Bulletin No.: PI1188

Service Bulletin

Subject: Duramax® Fuel Temperature Sensor Contacts Fuel Return Pipe After Pump Replacement

Models: 2012-2014 Chevrolet Silverado 2500/3500
2012-2014 GMC Sierra 2500/3500
Equipped with 6.6L Diesel Engine (RPO LML)

3629232

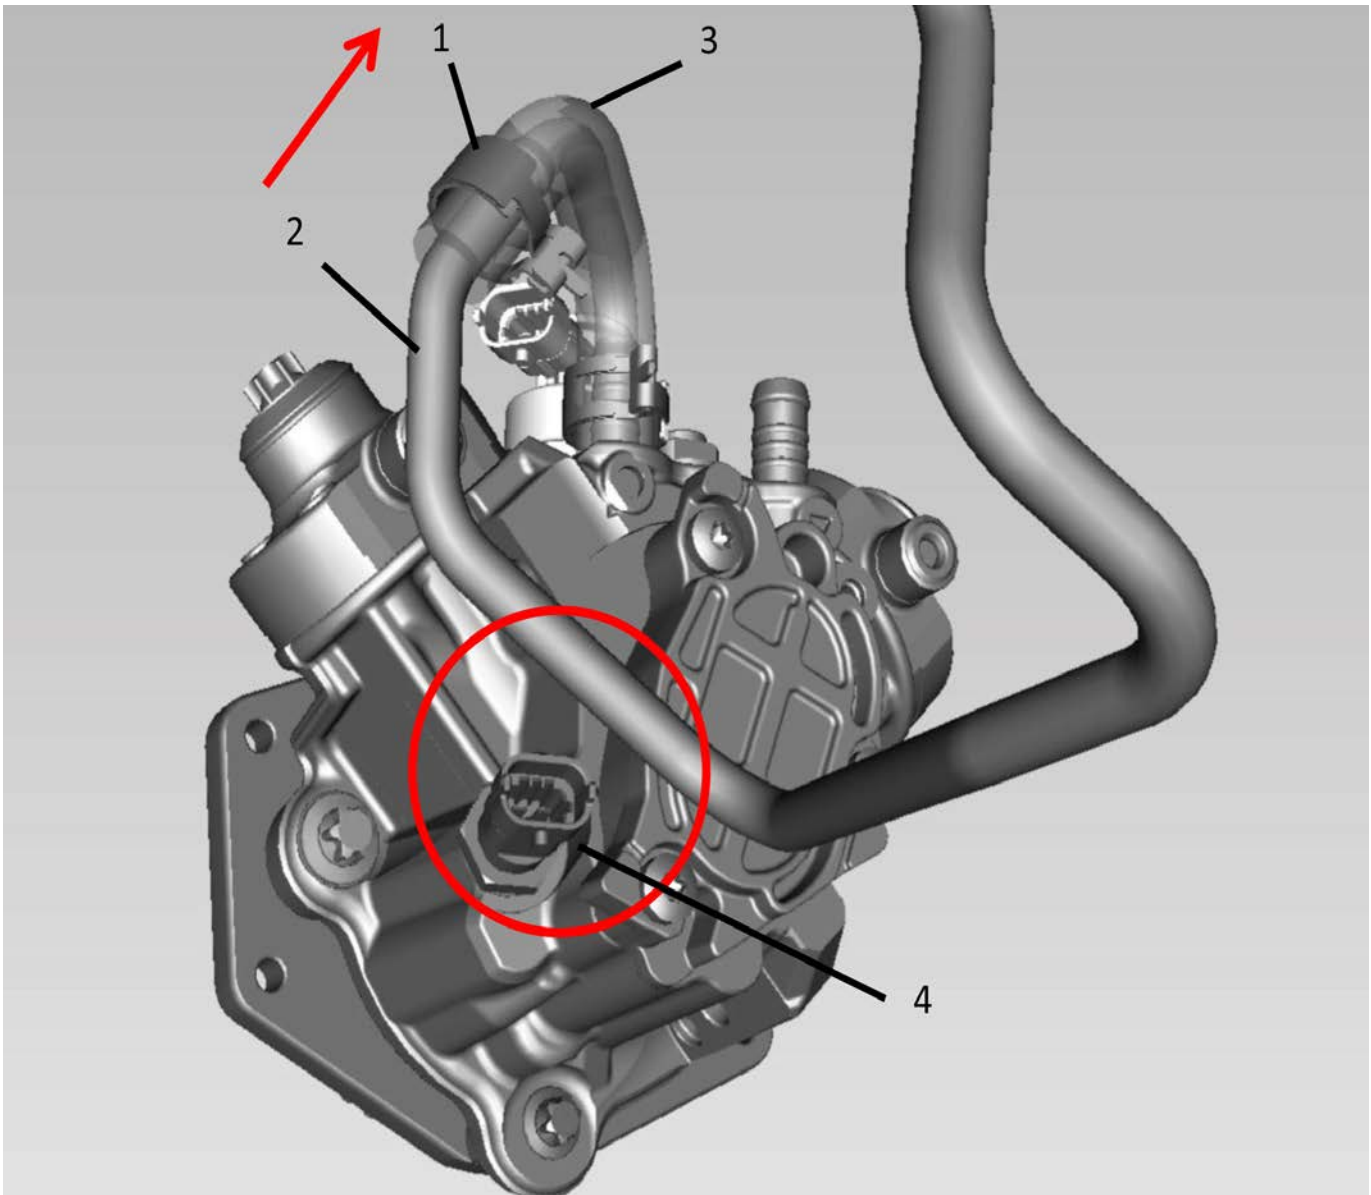
The following information may be helpful for a technician when replacing a fuel pump. If there is contact between the fuel temperature sensor connector and the fuel return line or clearance is very tight, please follow this service recommendation.

Follow the procedure below for inspecting the fuel return pipe to see if adjustment is needed. If sufficient clearance of 5 mm cannot be obtained through adjustment, replace the fuel return pipe with the newer design.

1. Remove the fuel return pipe to fuel return hose clamp (1).
2. Adjust the fuel return pipe (2) deeper into the fuel return hose (3).
3. Rotate the pipe assembly away from the fuel temperature sensor (4).
4. Install the fuel return hose clamp (1).
